# SERVICE INFO

## Assembly instructions for LuK RepSet® 624 3200 09 and 624 3200 34

**LuK RepSet®:** 624 3200 09  
624 3200 34

**Image 1:** Clutch disc with plastic ring

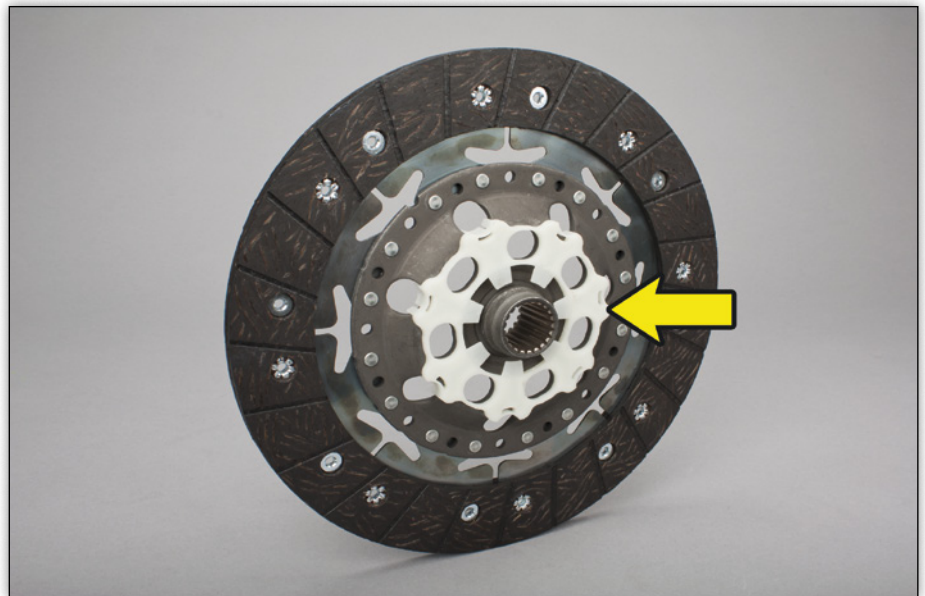
A DFC (Damped Flywheel Clutch) is installed ex works in the vehicles mentioned above. The DFC is an upgrade of the dual mass flywheel. In the DFC, the clutch disc, clutch pressure plate, crankshaft screws and dual mass flywheel are combined in one compact module. To simplify the process of fitting it to the engine in series production, the clutch disc is equipped with a plastic ring. The purpose of this ring is to hold the crankshaft screws in the holes in the DFC.

Clutch discs without a plastic ring were generally included in previous LuK RepSets®. Depending on the frequency of repair, either clutch disc version may therefore be installed in the vehicle.

Schaeffler Automotive Aftermarket now only includes clutch discs with a plastic ring in LuK RepSets®.

The plastic ring has no influence on the function of the clutch!  
It can be left installed or can equally be removed!
